REPLACING PAGE ADDENDUM

RECORDER-REPRODUCERS

KS-12055 L4 AND L6

PIECE-PART DATA AND REPLACEMENT PROCEDURES

Fig. 1—KS-12055 L4 and L6 Recorder-Reproducer—Front View

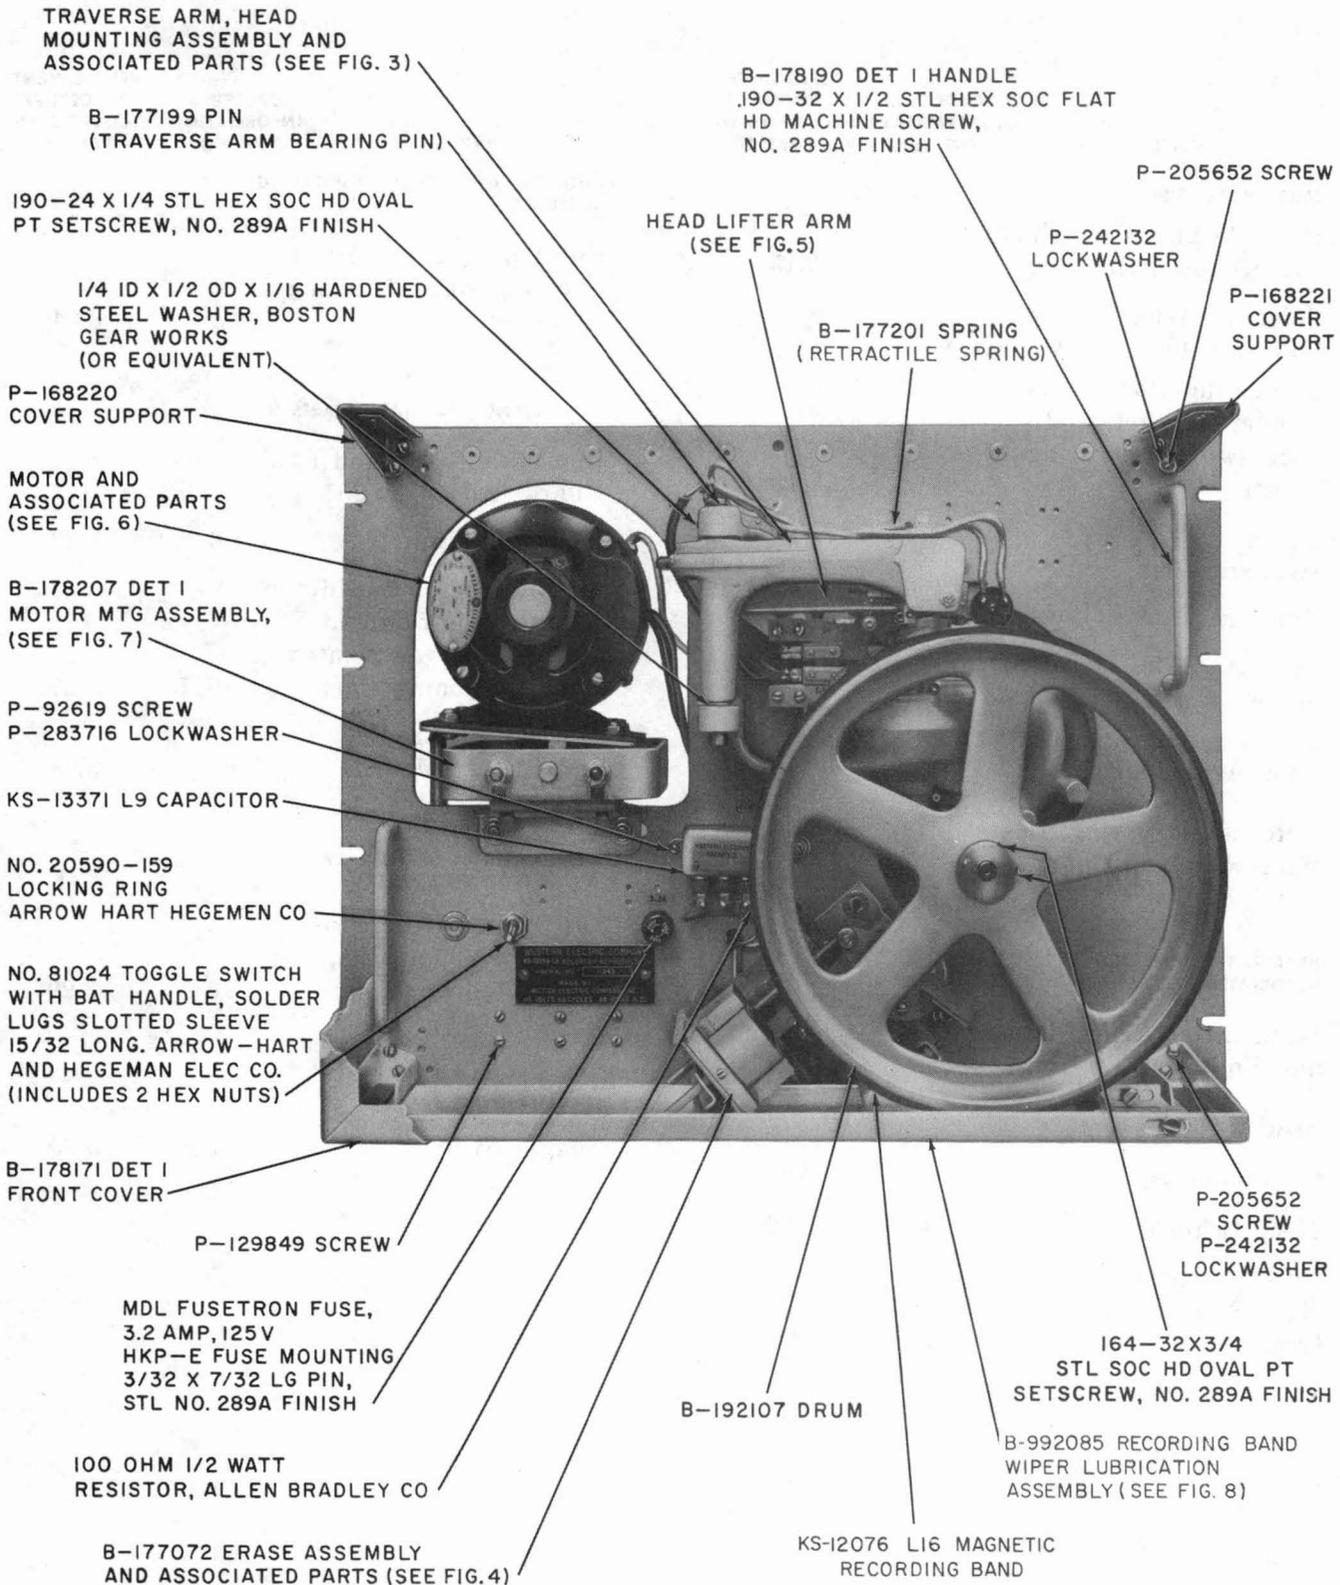
1.002 This addendum is issued to replace SF-96-500 silicone fluid with SF-1147 silicone fluid.

(b) 3.06(4)—revised

- (4) Place one tablespoonful of SF-1147 silicone fluid in the bottom of the slide assembly. Make sure the felt wiping pad is uniformly saturated with silicone fluid.
- (5) Adjust the slide assembly so that the felt wiping pad fits snugly with light pressure against the recording band. Ensure that no metallic portion of the wiper assembly comes in contact with the recording band (Fig. 1). Secure the slide assembly by firmly tightening the two adjustment screws in the end of the slide. Manually rotate the drum clockwise as described in 1.07. As the drum is rotating, silicone fluid shall be uniformly distributed over the entire recording surface of the band.
